413 3RD AVE W
DESIGN REVIEW BOARD
2ND EARLY DESIGN MEETING
MAY 2ND, 2018
SDCI Project: #3027575

2ND EARLY DESIGN MEETING
MAY 2ND, 2018

EDG-1 BOARD RECOMMENDATIONS

Entry & Lobby

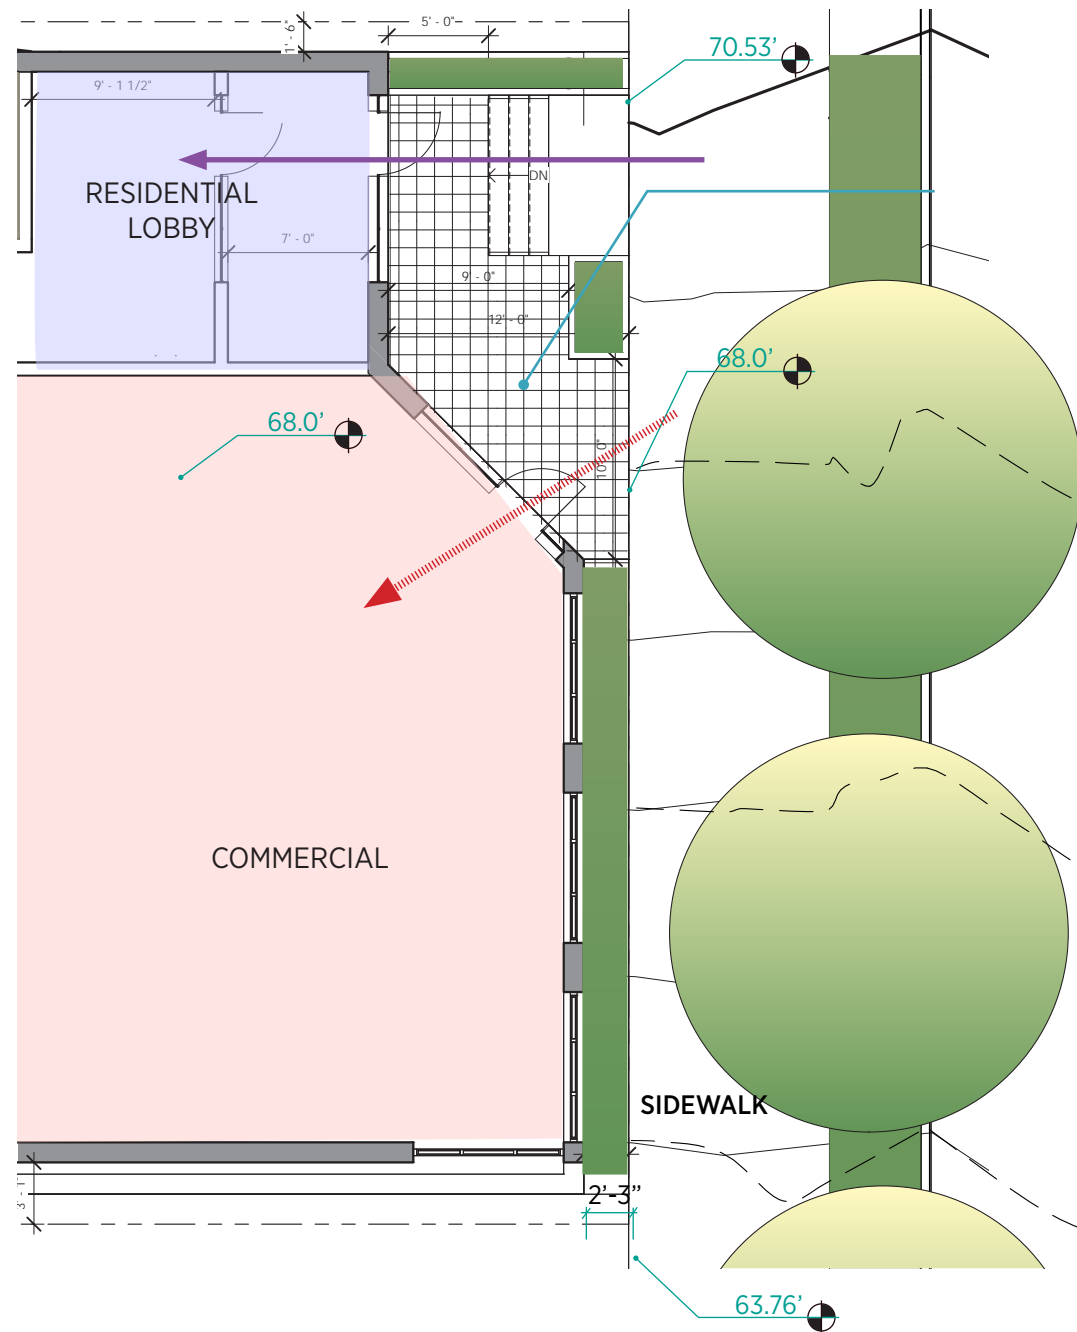
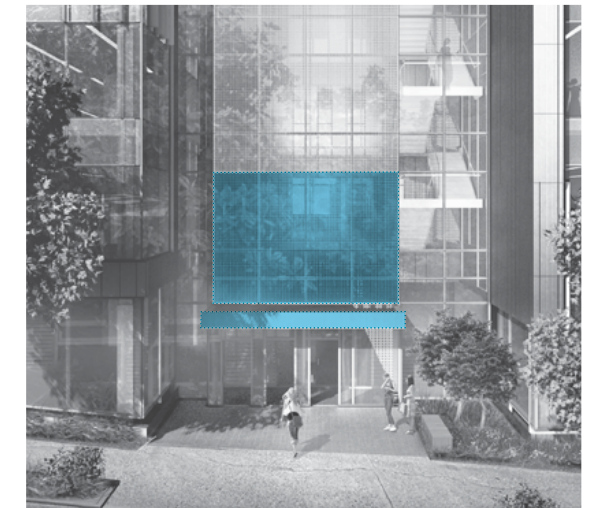
A. The board directed further development of a visually distinctive entry and lobby that is reinforced by the architectural concept and composed of a collection of coordinated elements. (PL3-A-4)

B. The board noted that the shared commercial and residential entry/lobby provides an interesting design opportunity since it concentrates pedestrian activity in a singular location on site. The lobby should be well designed as a lively space (PL3-A-4,DC1-A-1,DC1-A-4)

E. The board was concerned that the ground-level patio along the street edge did not respond to topography. (CS2-B-1)

A 2'-3" wide Landscape green space is provided along the side-walk, which wide the sidewalk to enhancing the pedestrian walking experience, while responding to the changing grade.

Open entry provide human scale activity to street and create active outside space. The continuous transparent glazing corner differentiate commercial from the residential entry.

Open entry space matches party the street topography, providing easy access for commercial and residential use.

Landscape along the entry, helps the transition of topography and building entry level, while provide separation differentiate the commercial and residential entry.

Bike Storage

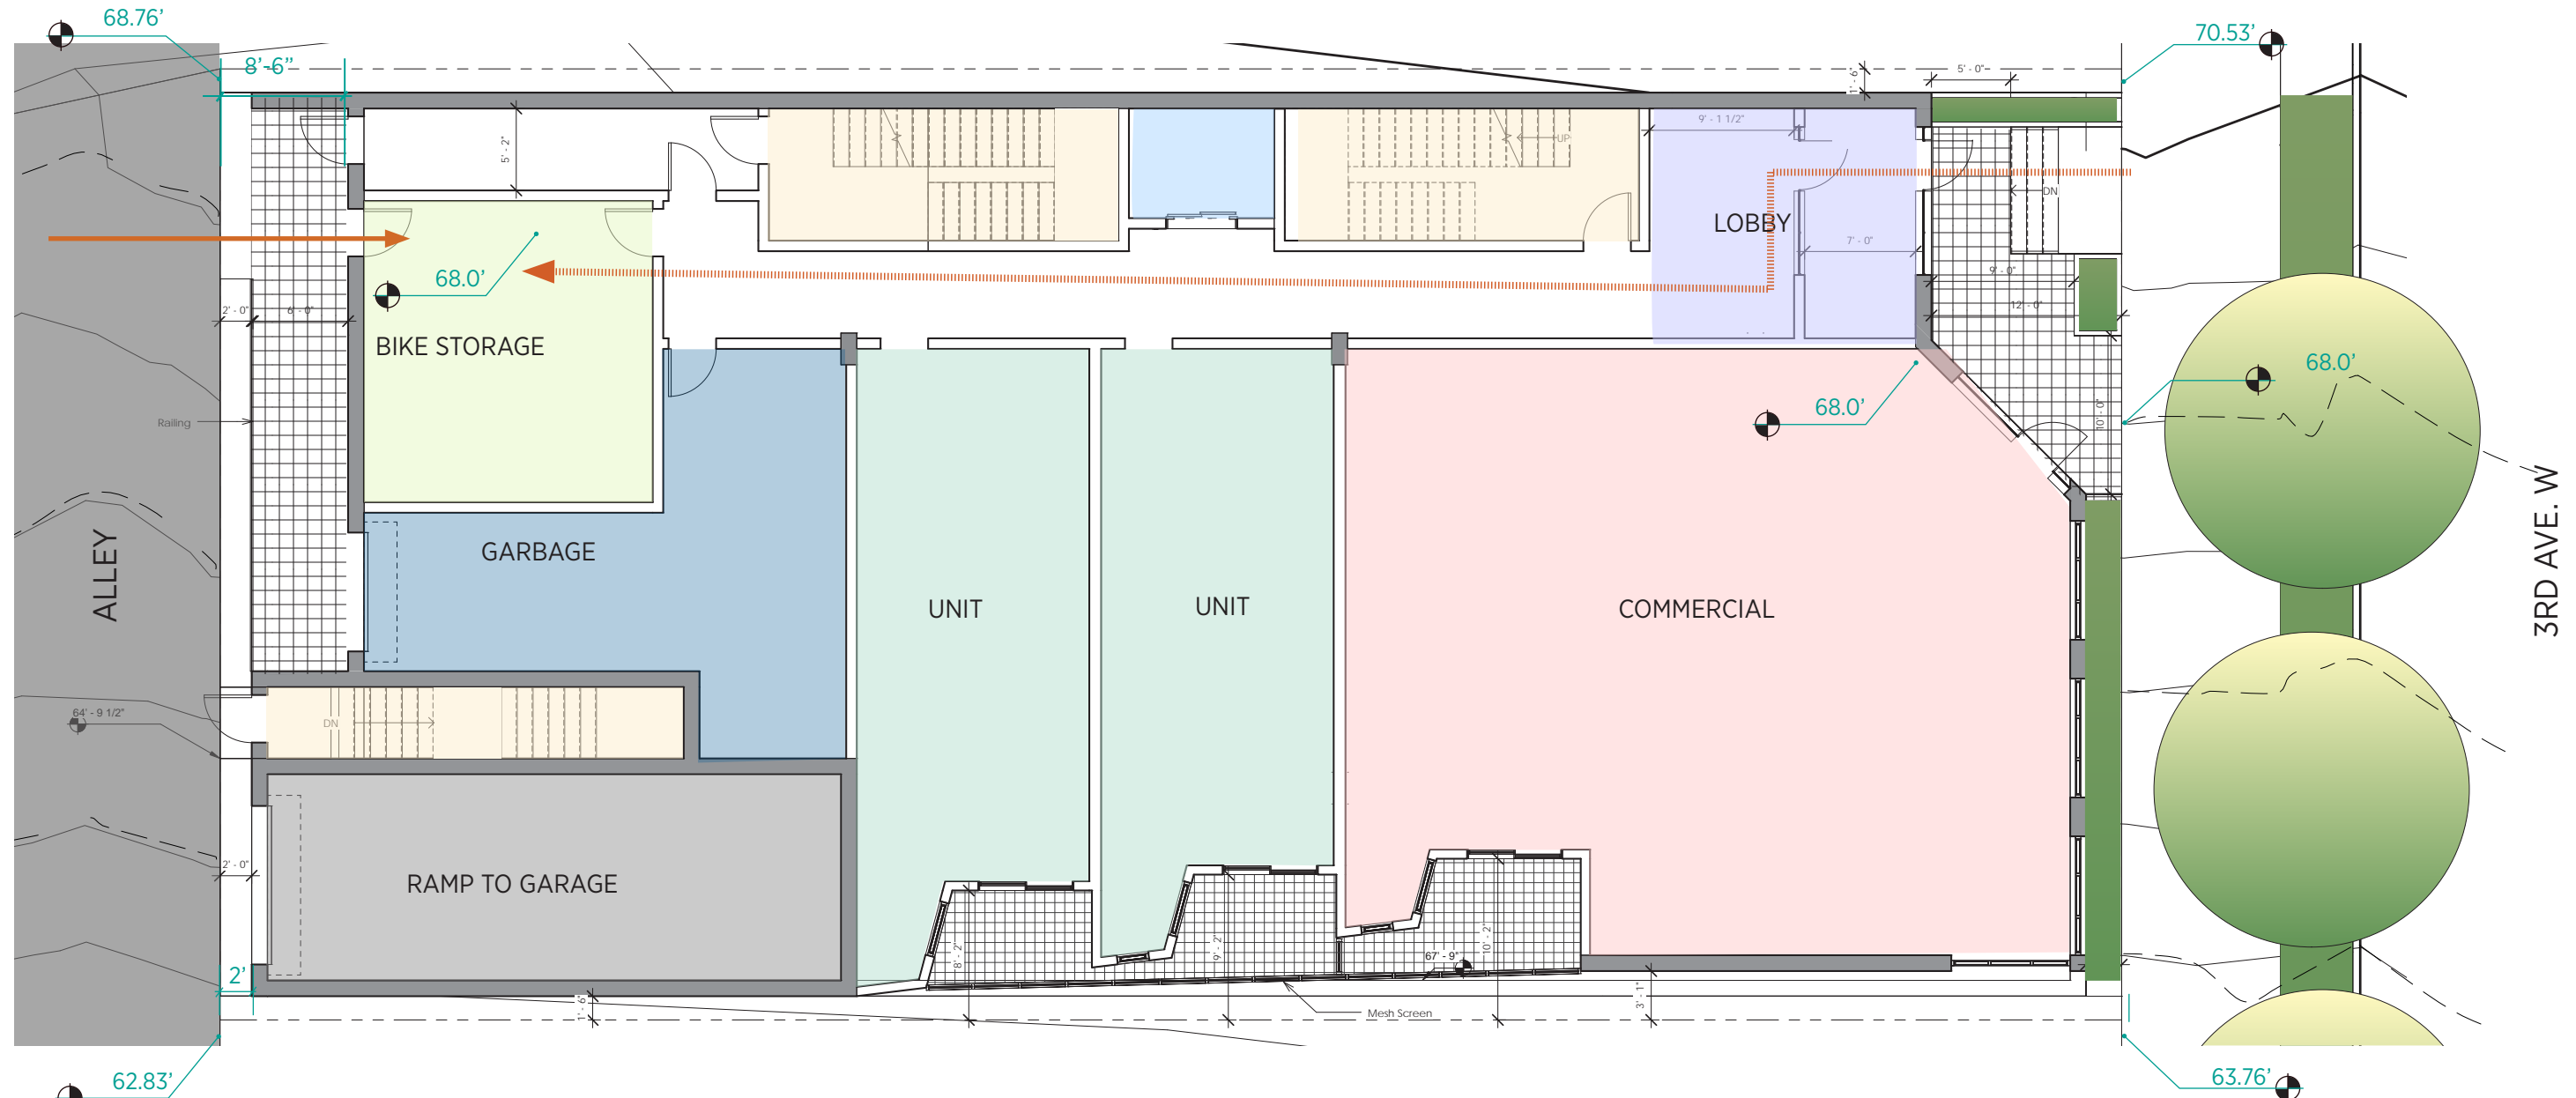
C. The board was concerned about access to the basement bike storage room via the primary entry and elevator. (PL3-4-A, PL4-B)

PL4-B Planning Ahead for Bicyclists
 The bicycle room is relocated along the alley on the ground level, instead of in the basement that proposed for the EDG-1 meeting. The new location provides easy access for bicyclists either enter directly from the alley, or from 3RD AVE W from the main lobby.

Southeast Corner Articulation

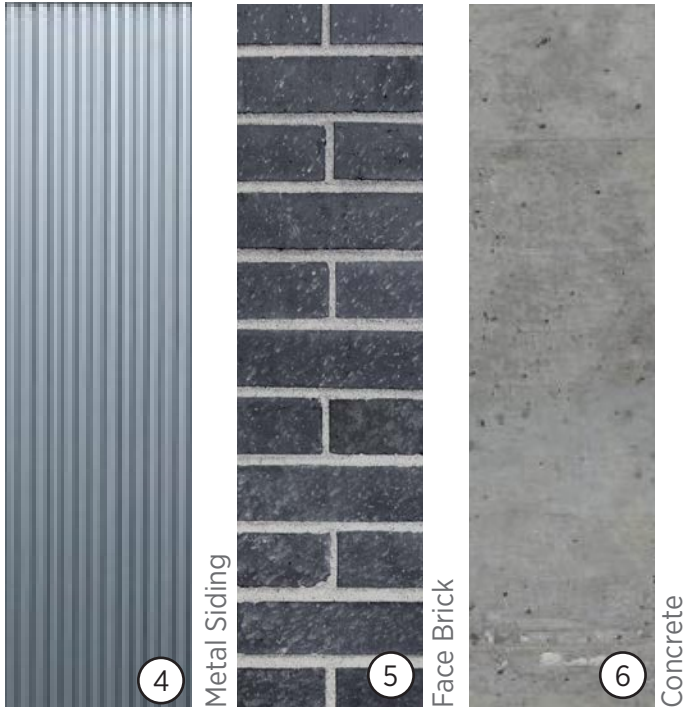
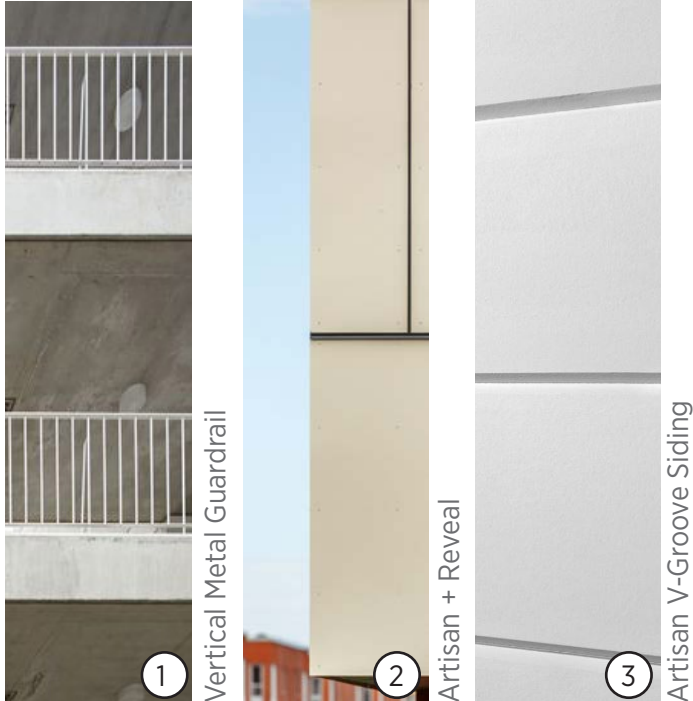
- A. The board encouraged further exploration of a flipped massing option so that the integrated modulation is presented to the public realm, particularly from a southeastern vantage point. (DC2-B, DC2-C-1)
- B. The board prioritized the development of the treatment of the southeast corner and south facade. (CS2-C-1,DC1-II,DC2-B)
- C. Blank walls on the south facade should be minimized or mitigated as the design develops. (DC1-II, DC2-B)
- D. The board requested perspective graphics depicting views of the north facade and more information on the design and height of any rooftop structures, including the elevator, M/E and stair penthouses. (DC1-II,DC2-B,DC3-A-1)
- E. The board encourage further development of the material palette and facade treatments. (DC2-I-iii, DC2-C-1, DC2-I-ii-g, DC4-A)

Angled south facade orientates window openings toward southeast corner. The angled facade avoids direct visual contacts toward the church office building, which has large percentage of window opening on north. Balcony space along south further provide visual buffer, while creating interesting massing concept, a transition from solid to void.

The street facade uses the similar architectural features, with balcony elements and oriented windows to ensuring the privacy of the units not facing directly to the office building across street which has massive glazing facade. The composition of solid and void strengthens the main concept, and indicating the integrity of the two massing.
